SERVICE BULLETIN SPSB008

SUBJECT: RELEASE CABLE TRIMMING

STATUS: MANDATORY INSPECTION

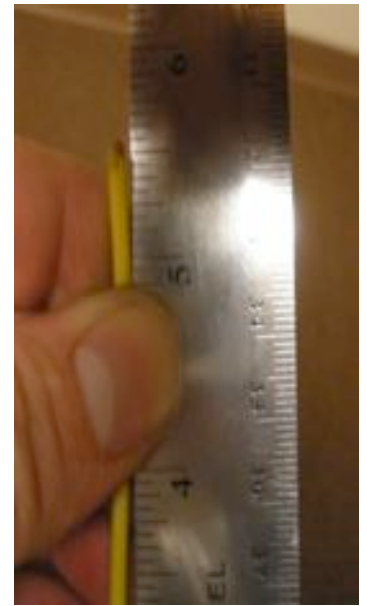
2. Ensure that the release handle is installed; Velcro mated and is all the way up to the top of the inside of the pocket.

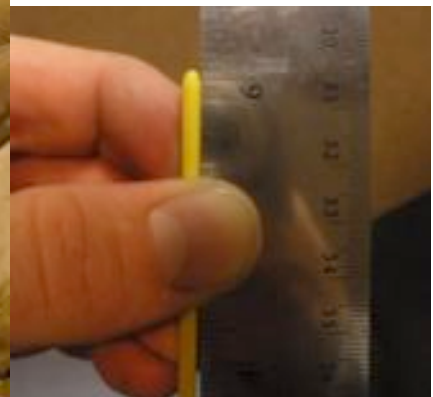
3. Remove any slack in the cables by pulling upward on both sides slightly. (A short tug/or pull on the cable end should take out any slack that may be in the system)
4. Place the rig on the ground or chair and allow the yoke area to relax and ensure your housings are seated/routed as if being worn. Specifically the loop area on the left side behind the main ring cover.
